Addendum No.: 3

Date Of Addendum: 5/21/2019

Rooftop A/C & Roof Replacement
300 Corporate Place
Rocky Hill, CT
BI – 2B – 387

ADDENDUM #3
**ROOF TOP A/C UNIT AND
 ROOF REPLACEMENT**
 300 CORPORATE PLACE, ROCKY HILL, CT
 Project No. BI-2B-387

- 1 EXISTING ROOFTOP UNIT, CONDENSATE PIPING, MOTOR/STARTER DISCONNECTS, CONTROLS, ETC. TO BE REMOVED. EXISTING STRUCTURAL STEEL SUPPORT TO REMAIN. ASSOCIATED SUPPLY AND RETURN DUCTWORK SHALL BE DISCONNECTED FOR FUTURE RECONNECTION.

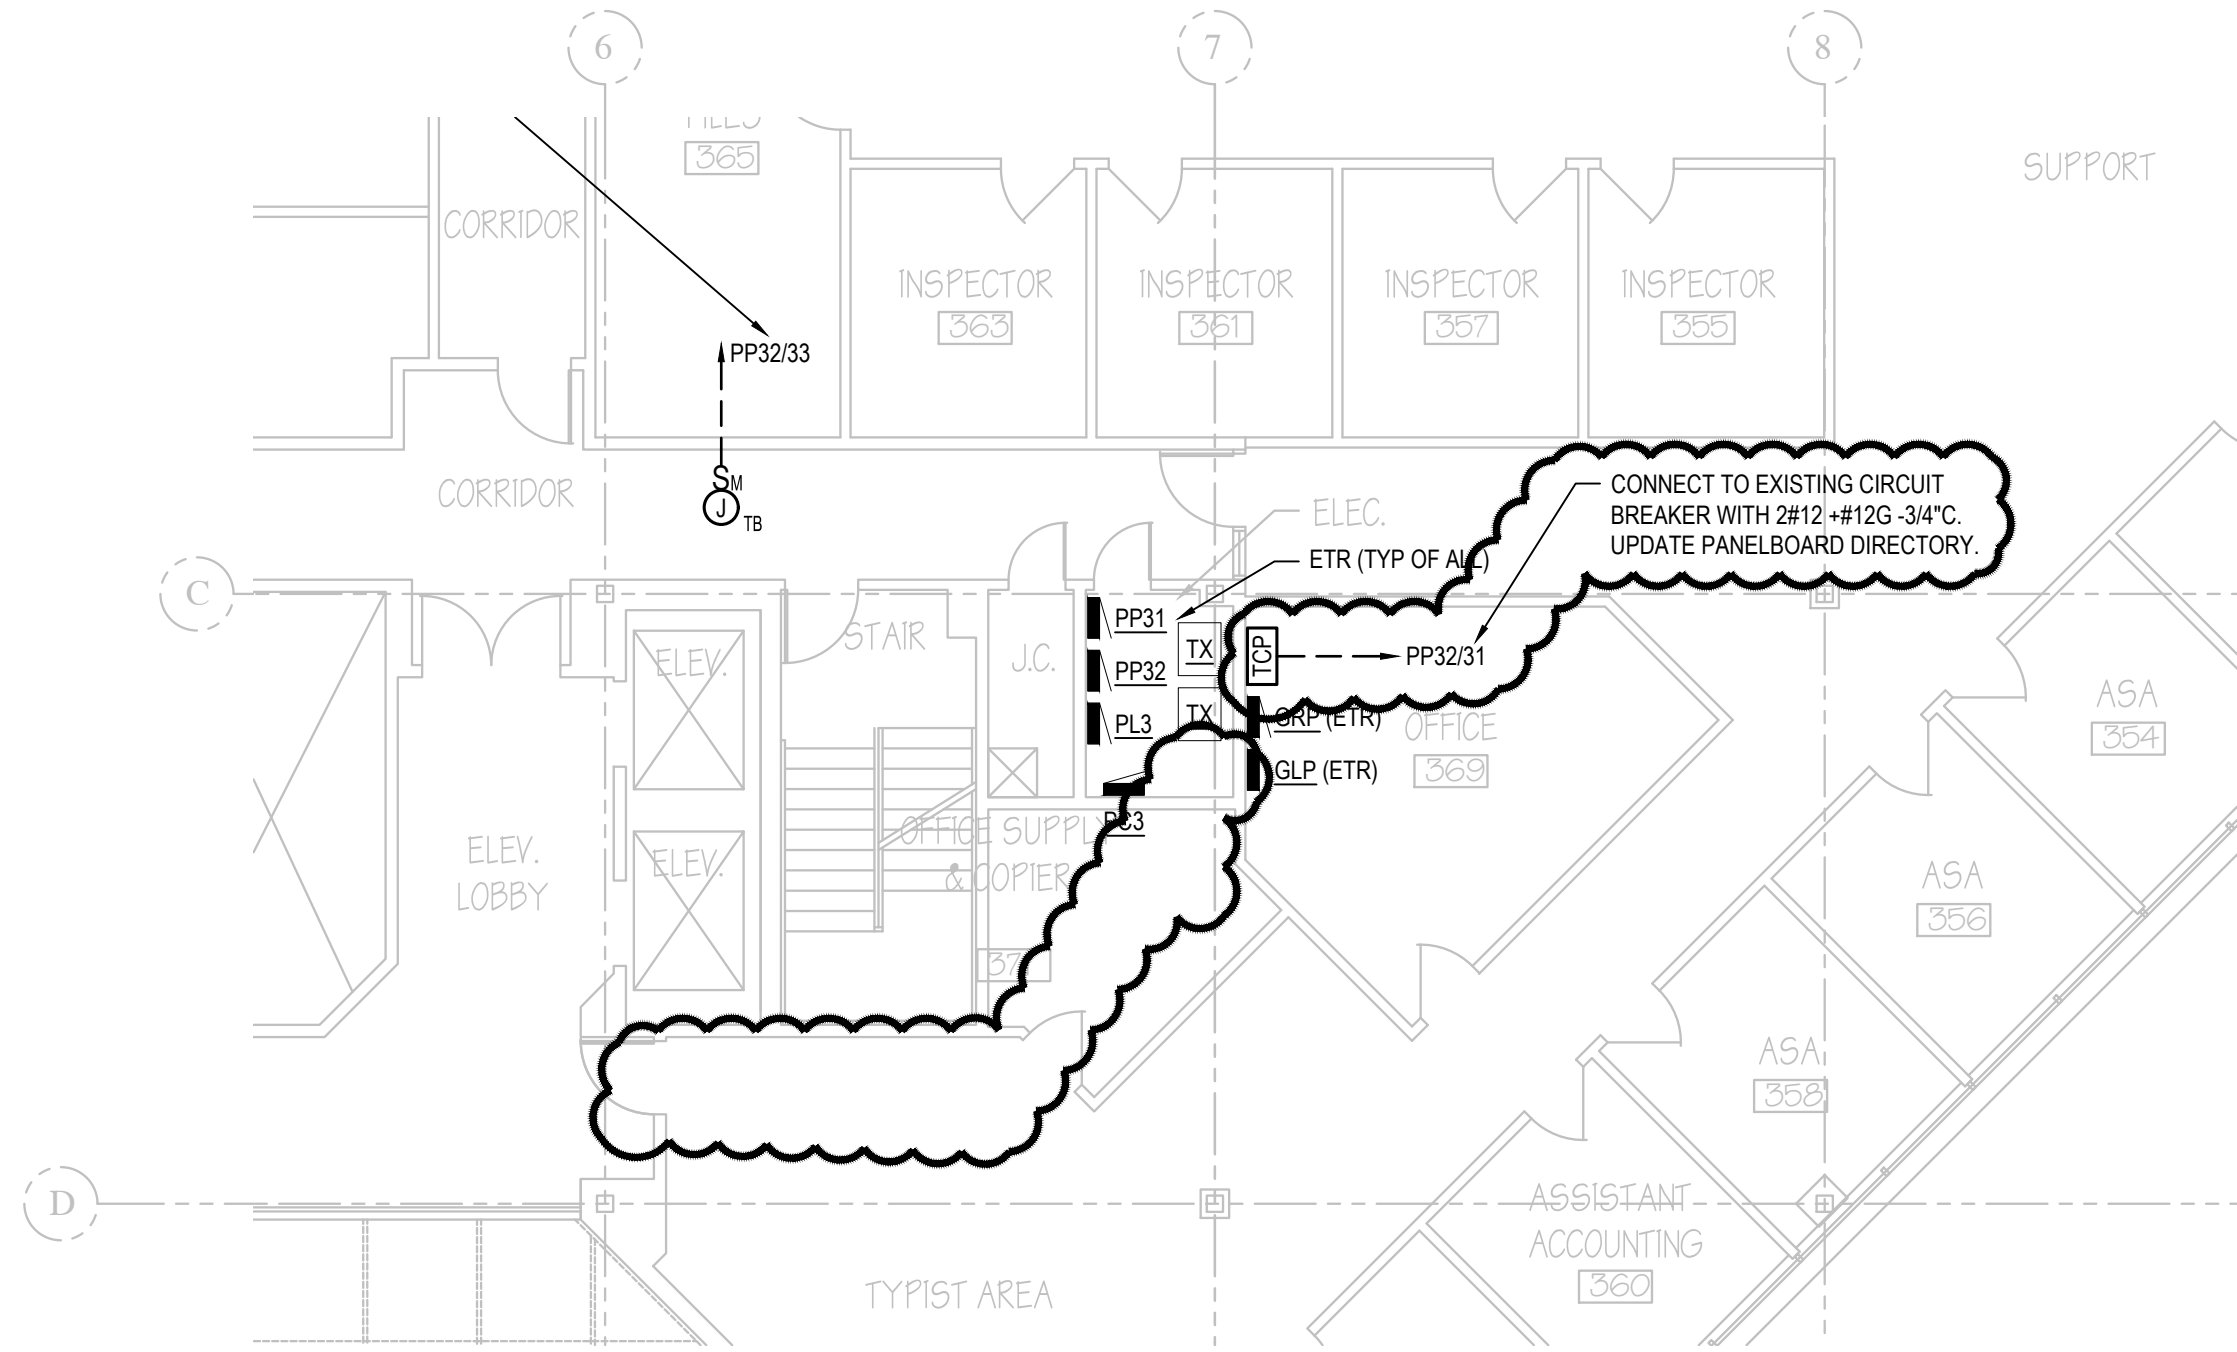
Revise Contract Drawings M-103 and E-103 with attached sketches **SKE-01** and **SKM-01** for location of TCP (Temperature Control Panel) in office 369 in order to provide proper clearances.

MAY 17, 2019
SKE-02
 DRAWING REF: E-101A

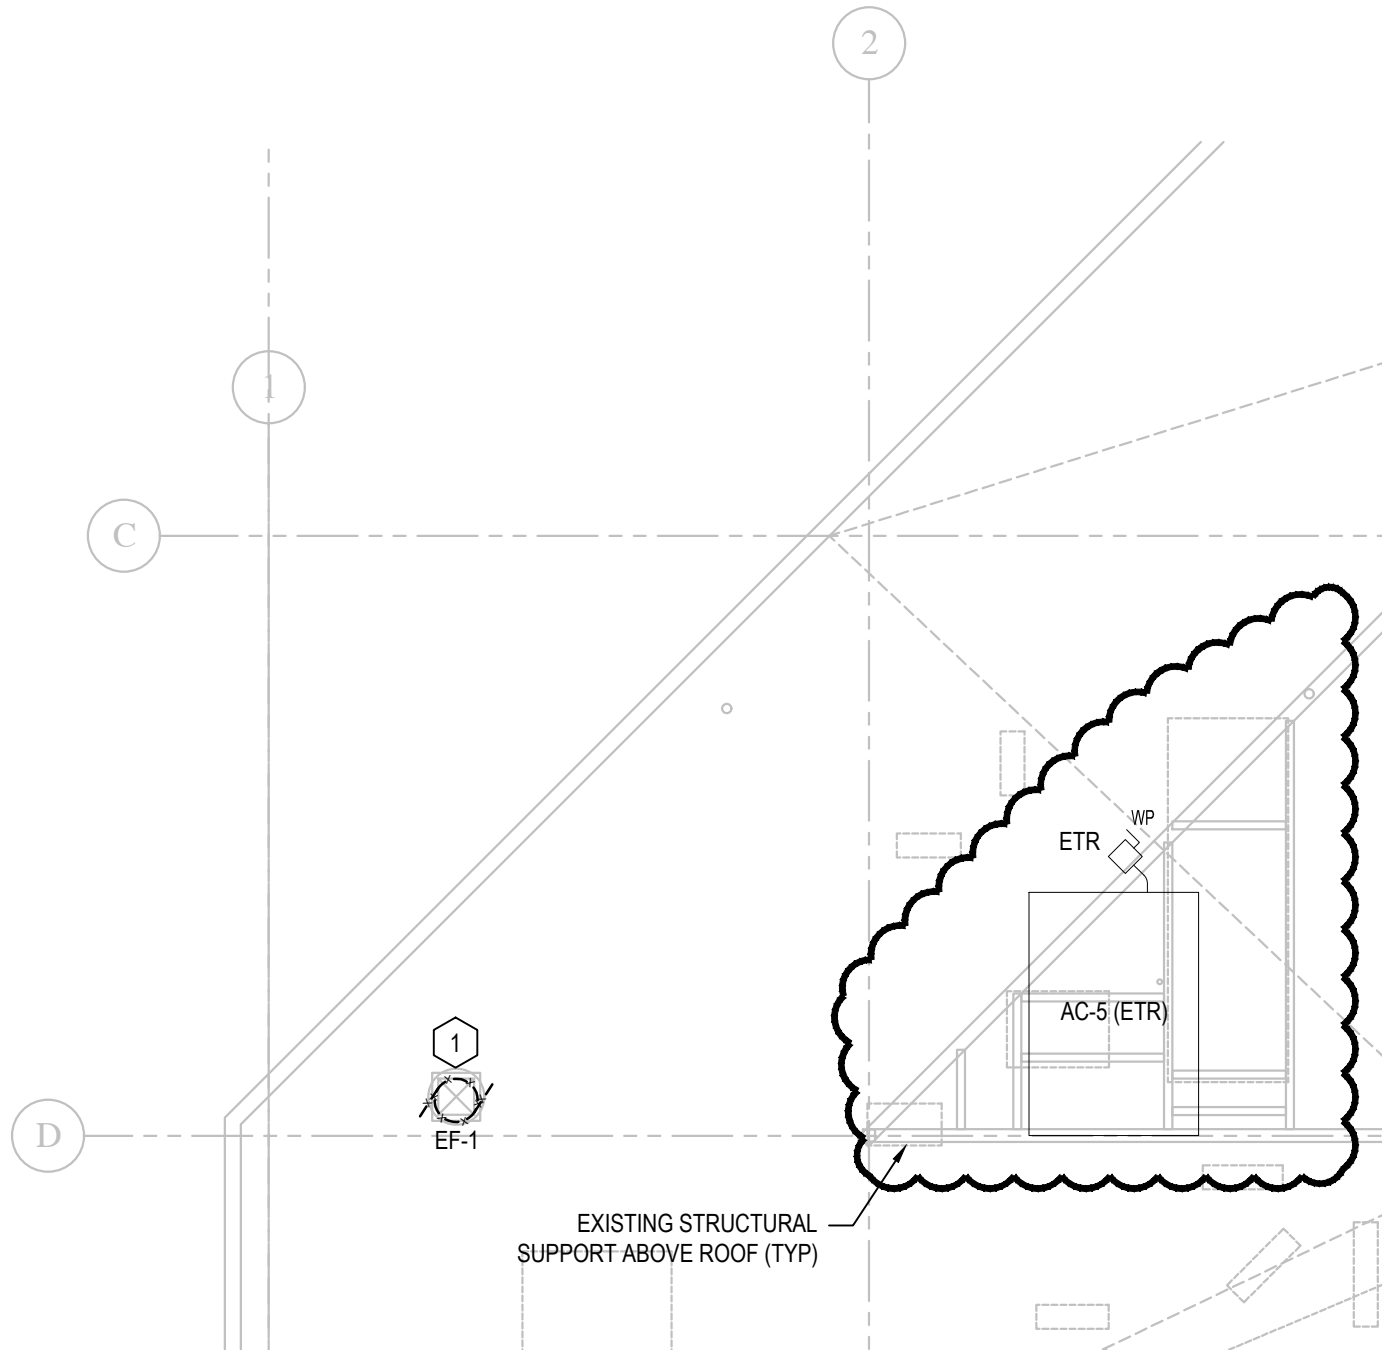
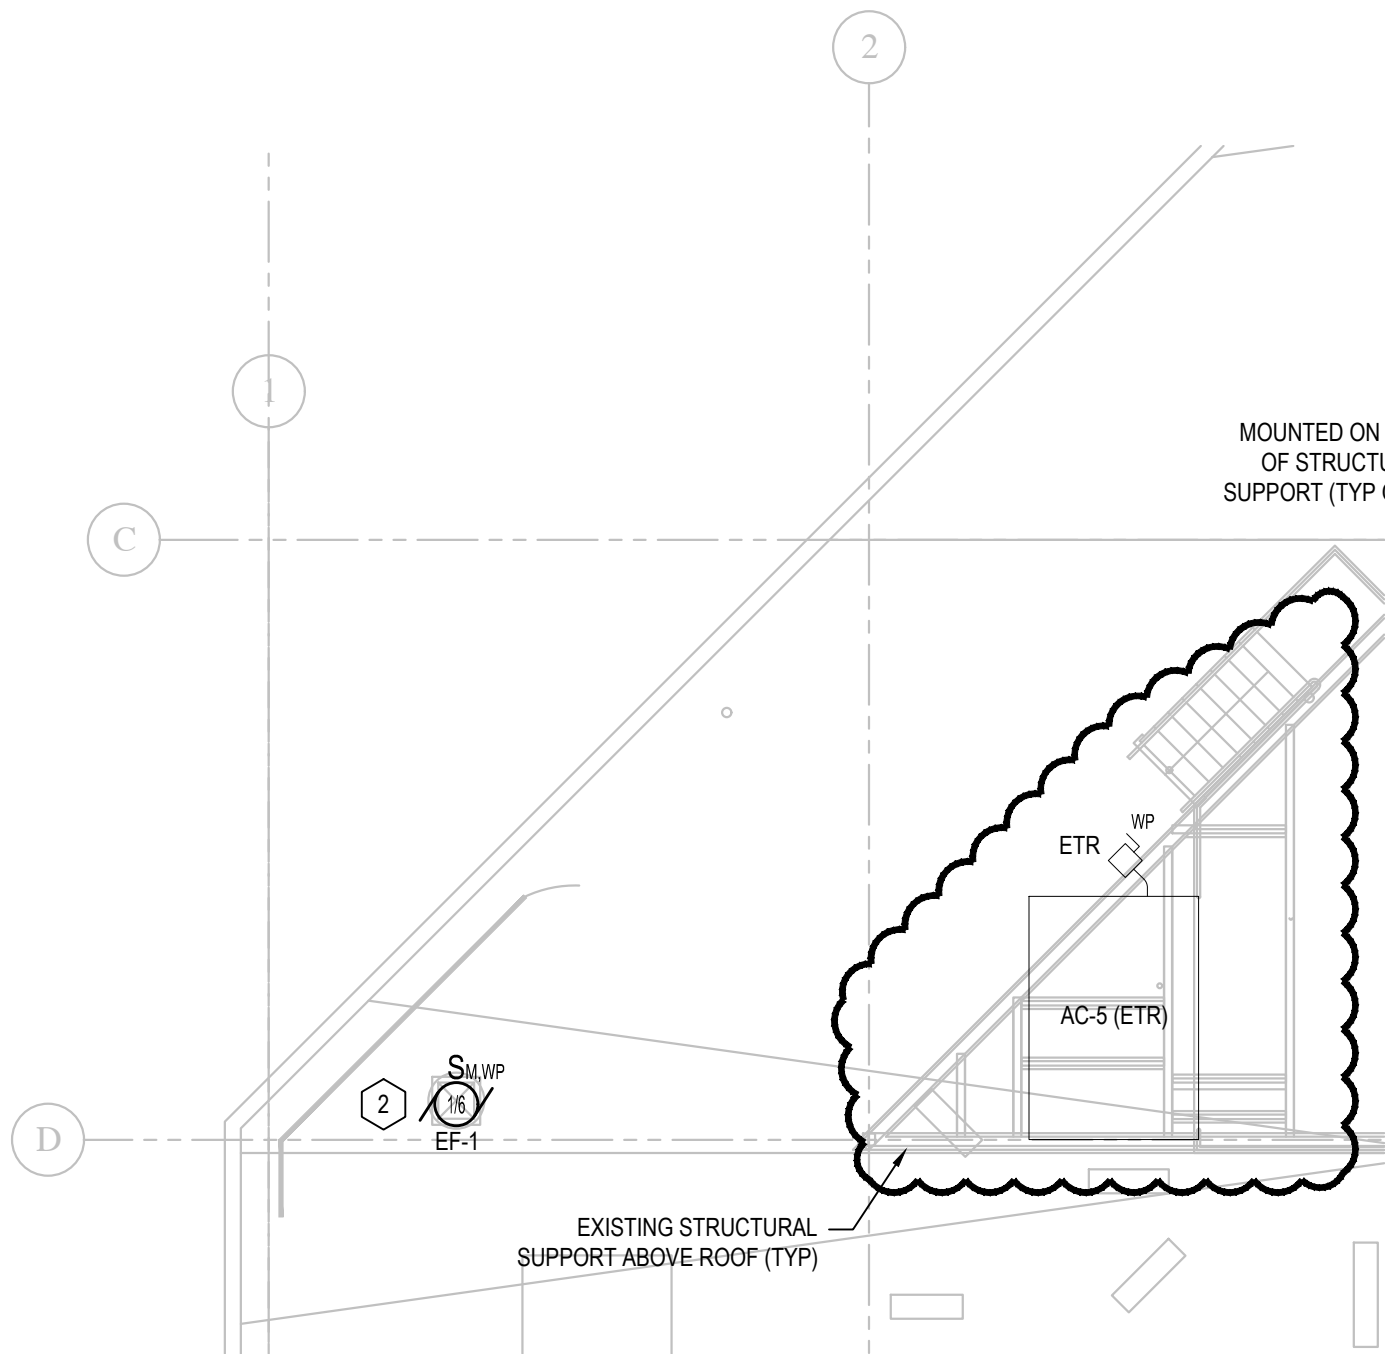
See attached to SKE-02 at Supplemental Bid #1 (Bid Documents E-101A) updated note references for extent of work and branch circuit notes.
